XLamp® XP-L S Line Photo Red LEDs Product Change Notification

PCN Reference Number: PCN-06137
Date Issued: August 19, 2026

Current Appearance

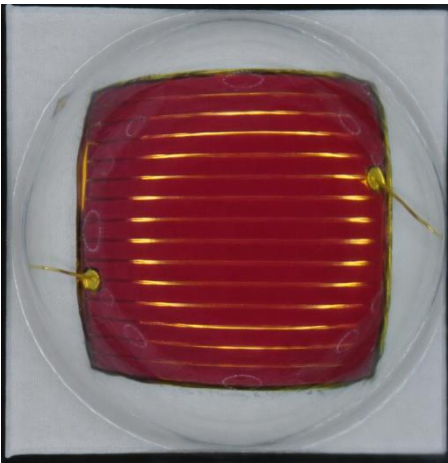
The appearance of the product has a qualified change. All of the appearances shown below are valid.
